ACRES CO.
WELLAND CANAL TUNNEL AT
DRILLING PROGRAM (AUG. 5-64)
THOROLD DIST. 4 (AUG. 26-64)
W.P. 445-64

Re: Thorold Highway Tunnel,
Site Investigation,
W. P. 445-64

Re: Thorold Highway Tunnel,
W. P. 445-64,
Your File No. 1161

SK-1161-SA-14

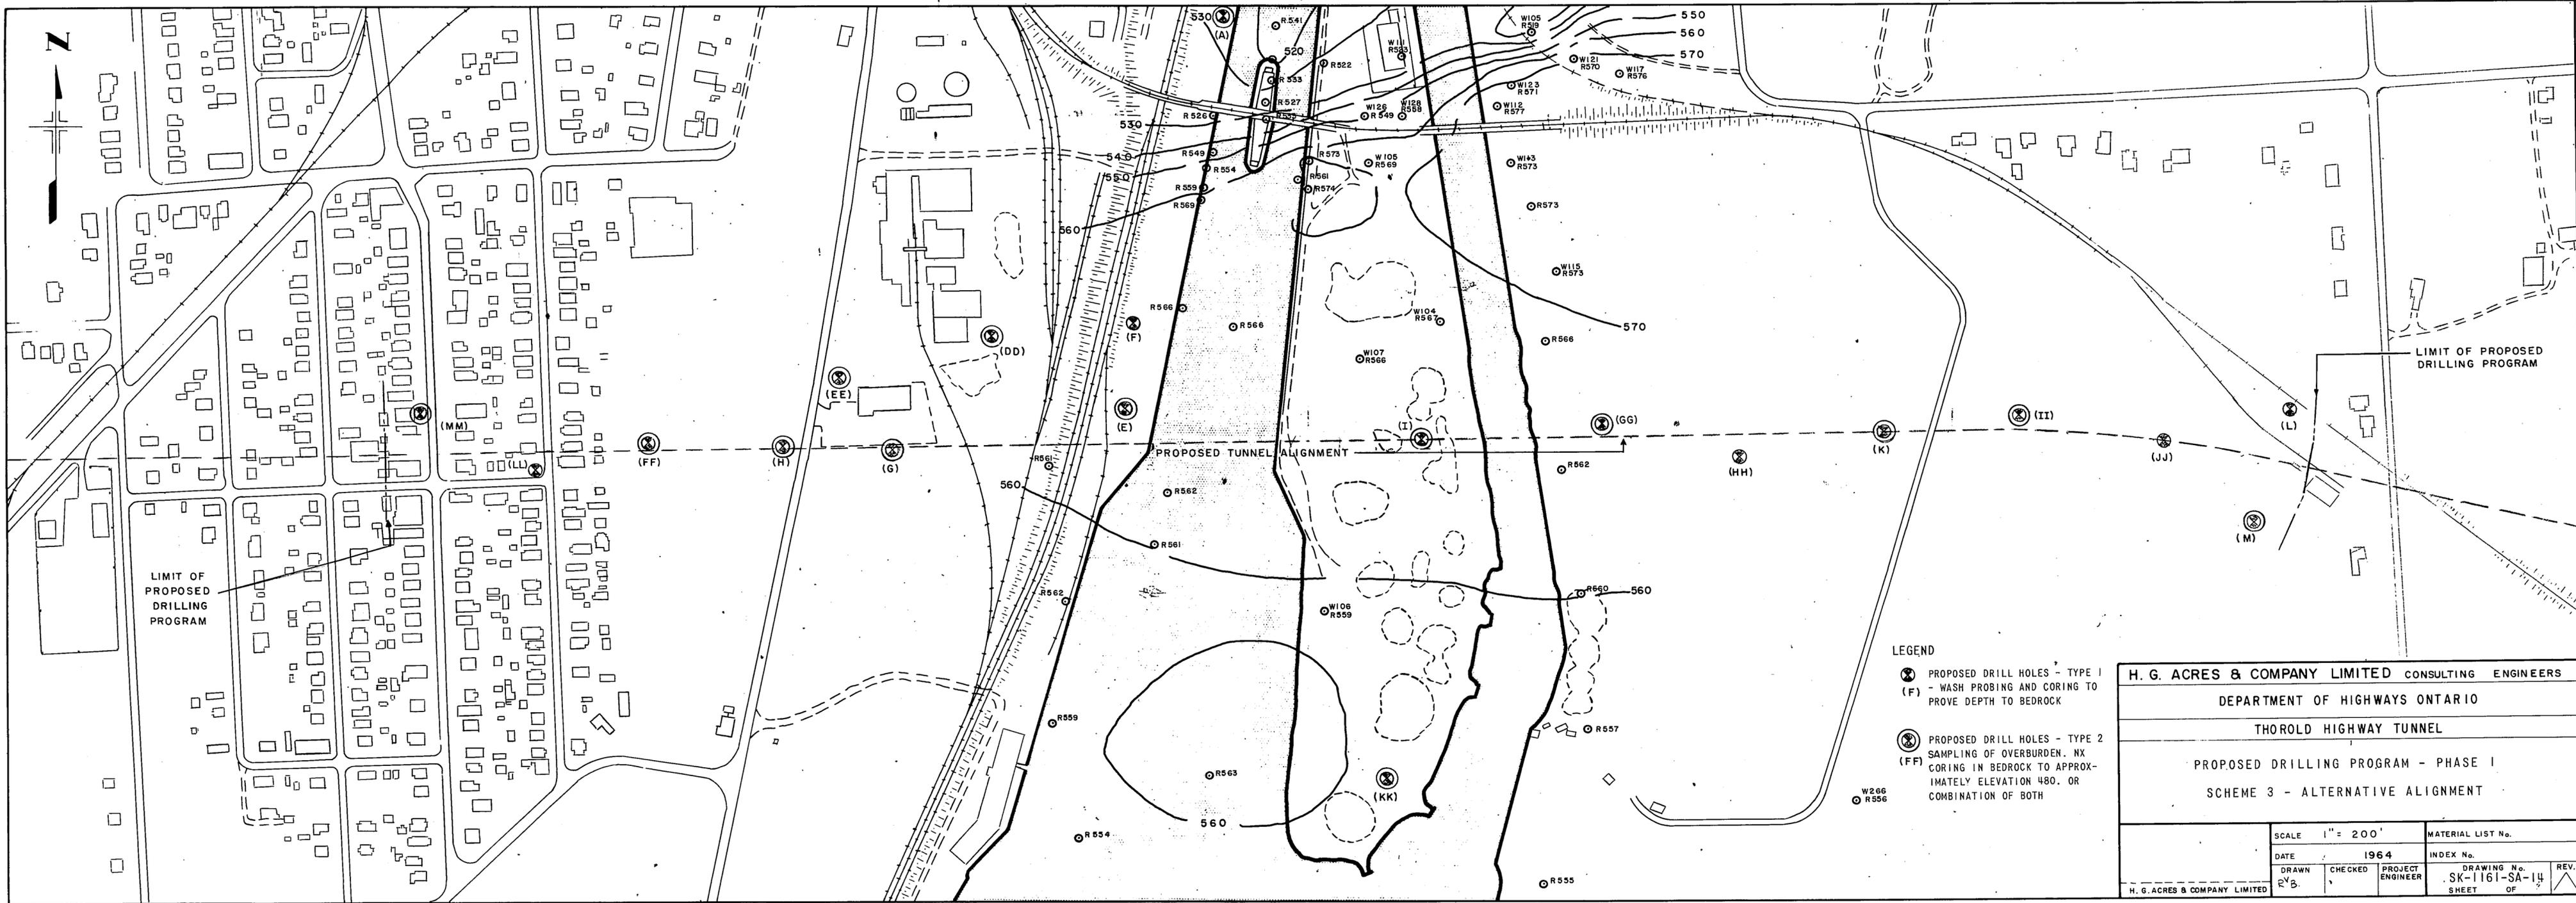
Thank you for your letter of August 5, 1964,
and for the drawing showing your proposed drilling
program, phase I, scheme 3, Alternate Alignment. Your
program and the additions to it, appear satisfactory,
and I have no comments to make at the present time.

SK-1161-SA-17

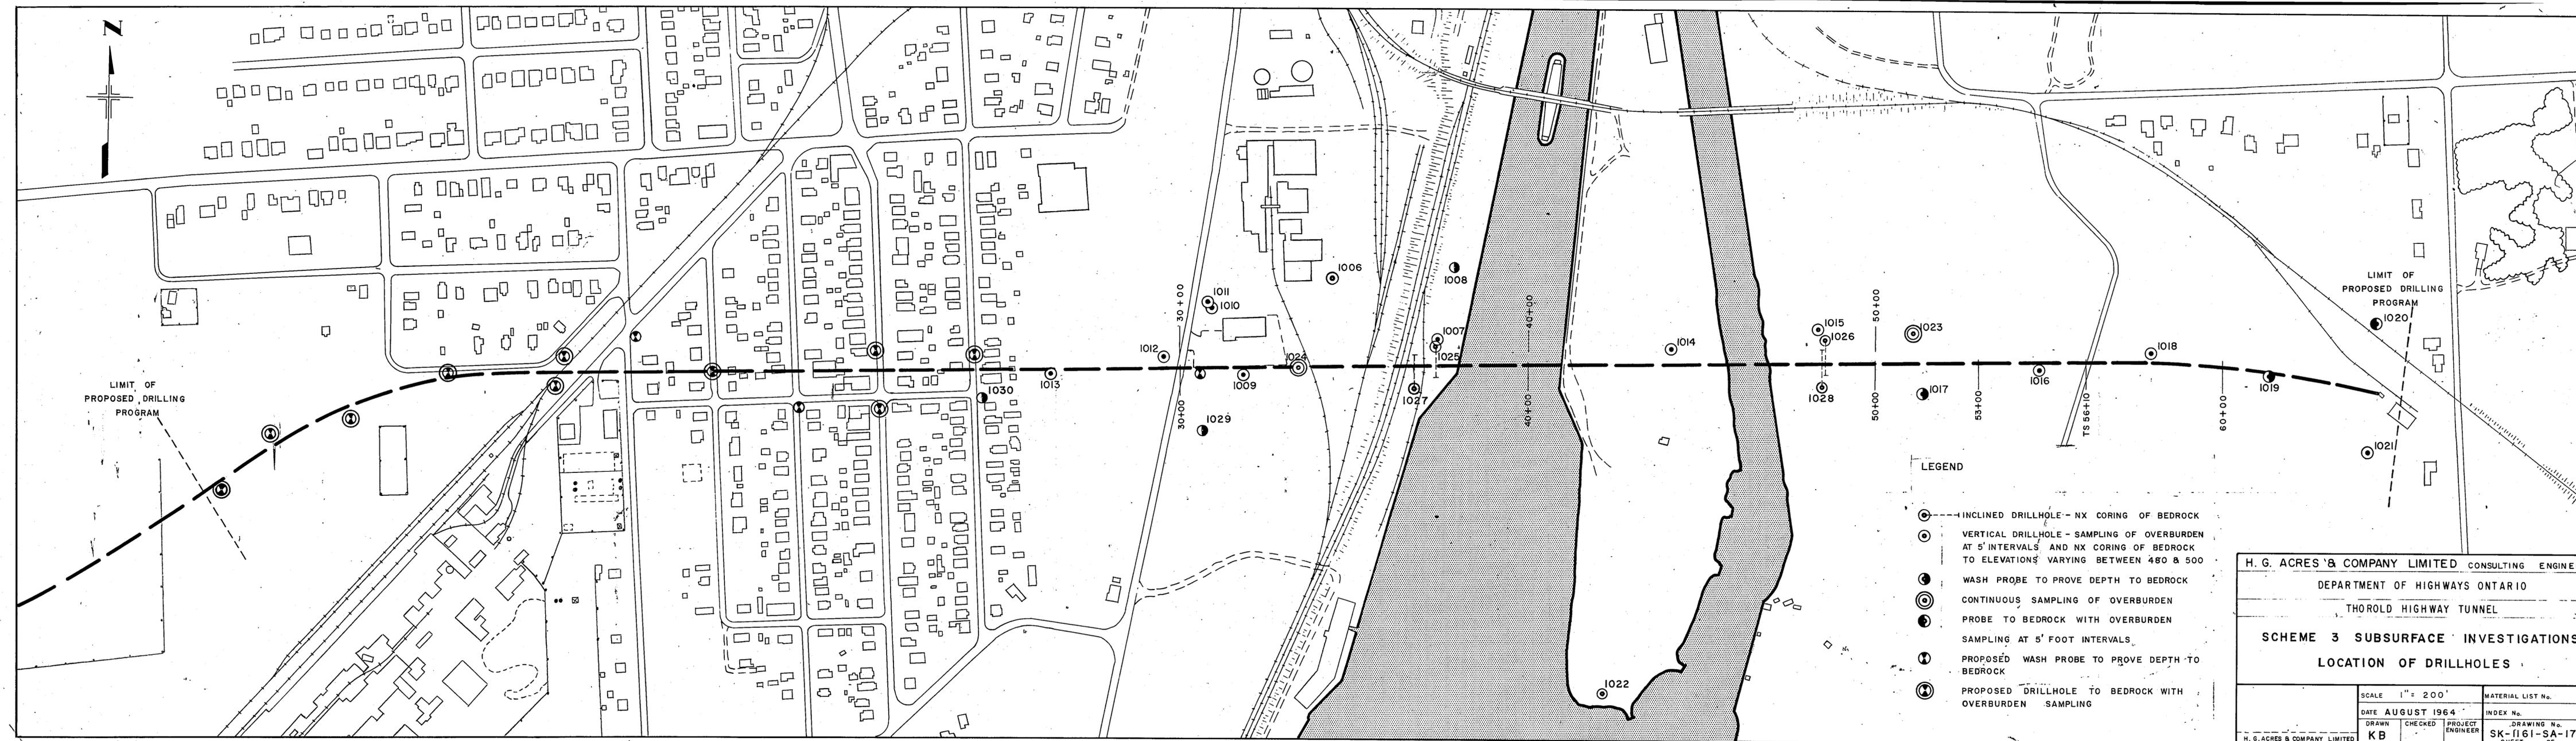
This will acknowledge your letter of August 26, 1964, and drawing SK-1161-SA-17, showing your boring program.

Your investigation for bridges, retaining walls and pavement design purposes, should be carried out in sufficient detail to determine,

1. Foundation designs for structures and retaining walls.
2. Bedrock profile so that accurate quantities can be determined of earth and rock quantities.
3. Suitability of cut material for embankment purposes (type of soil and moisture content).
4. Stability of earth cuts (if this is a problem).

If the bedrock surface is not flat, it may be necessary to place additional bore holes to obtain accurate quantities. You can decide this as your boring program progresses.
